LTFLU 三抵消、七线驱动10V

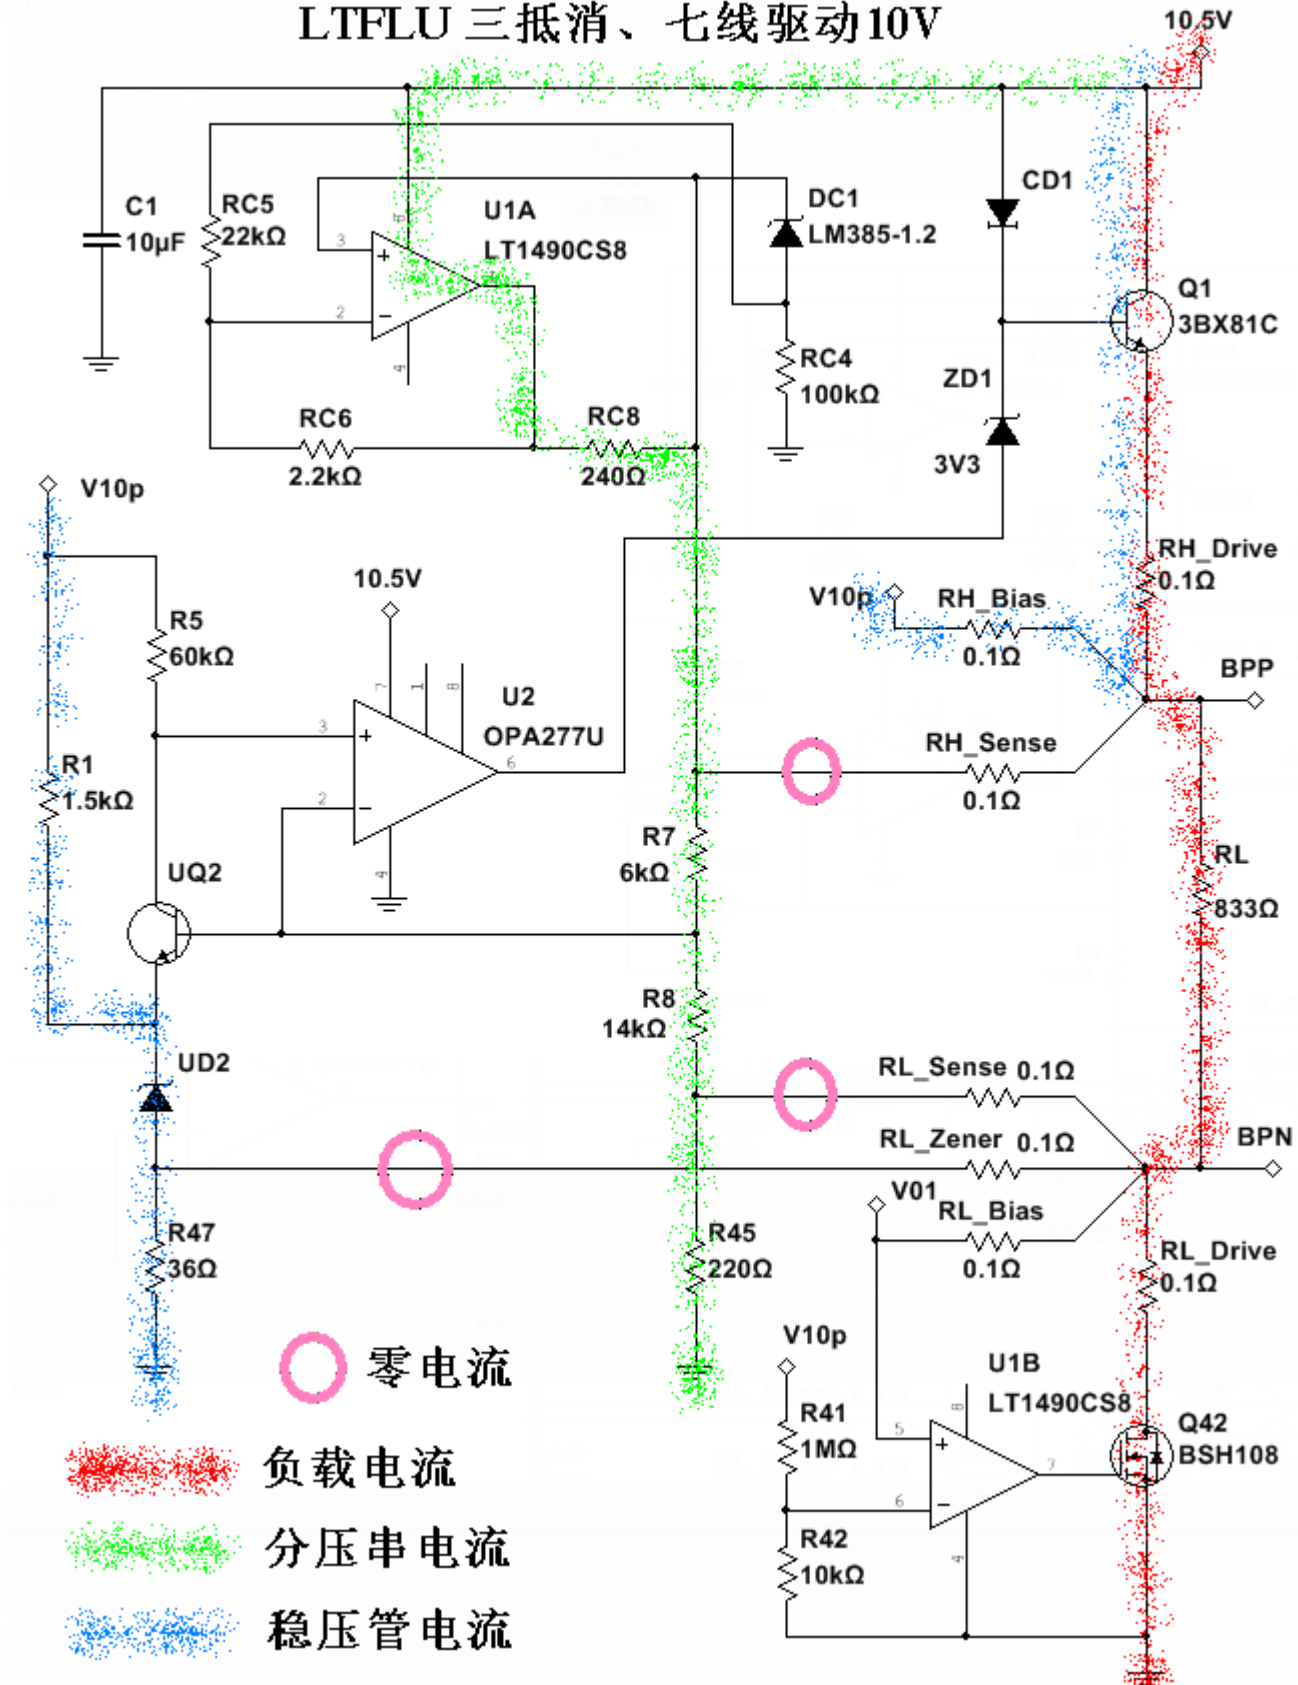
FLU current path: 10.5V, Q1, RH_Drive, RH_Bias, R1, UD2, R47, and ground.

Current path of voltage divider resistor string: 10.5V, U1A, 8 feet, 1 foot, RC8, R7, R8, R45, and ground.

In a word: for any precise voltage source, the current must have its own path, and the two voltage detection lines have no current.

Ask the boss, 7-line drive 10V high-side current compensation, why do we need a dedicated 1.25V reference to do it. No need to zoom in by 1.125 times for 10V to compensate

It is also possible to use 1.25V based on 10V, but the circuit is probably more complicated. To generate 1.25V with a dedicated reference, only one resistor and one zener are needed.
